Summit Repower Siting Process - Update to August 23, 2016 and November 10, 2016 reports.

June 29, 2017

Turbine site 1:

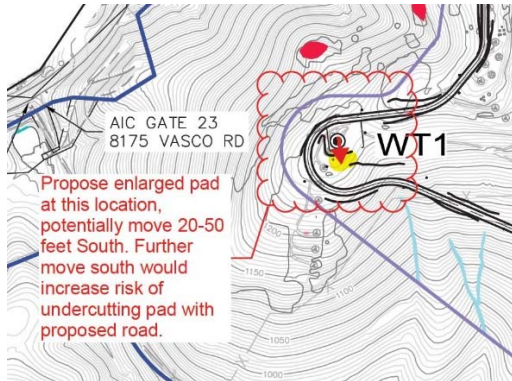
Dr. Smallwood's suggestion: "Move 20 to 25 meters south."

DK Consulting attempted to move turbine 1 south as recommended. They were only able to move the turbine approximately 50 feet (15.2 meters) south as moving it further would increase the risk of undercutting the proposed pad with the proposed road. See DK Consulting's notes regarding turbine 1 below:

Turbine site 13:

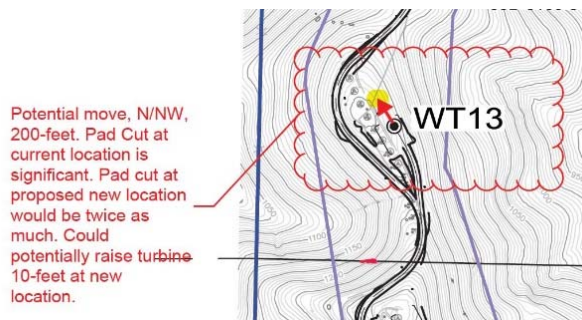
Dr. Smallwood's suggestion: "Move NNW away from saddle."

DK Consulting determined that turbine 13 could be moved NNW approximately 200 feet but would require an excavation of twice as large.

Turbine site 17:

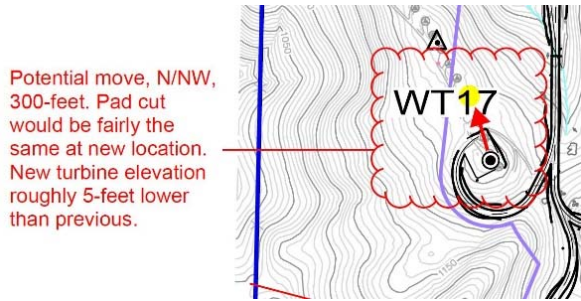
Dr. Smallwood's suggestion: "Move NNW across small saddle; too close to intensively traversed large saddle."

DK Consulting was able to move turbine 17 NNW 300 feet across the small saddle and away from the large saddle.

Turbine site 18:

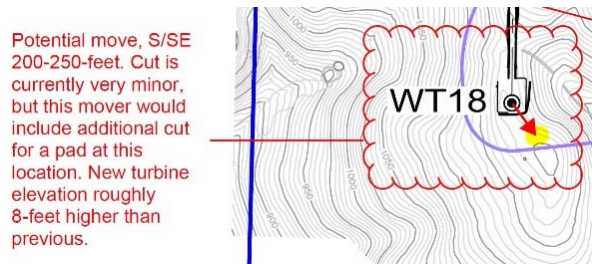
Dr. Smallwood's suggestion: "Met tower site would be safer, farther from saddle."

DK Consulting moved turbine 17 SSE approximately 200 feet towards the Met tower location and away from the large saddle. The "dot" is the Met tower.

Turbine site 32:

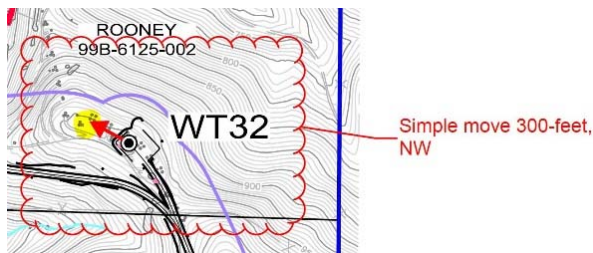
Dr. Smallwood's suggestion: "Move 40 meters WNW away from saddle; intensely used ridge."

DK Consulting moved turbine 32 approximately 300 feet northwest.
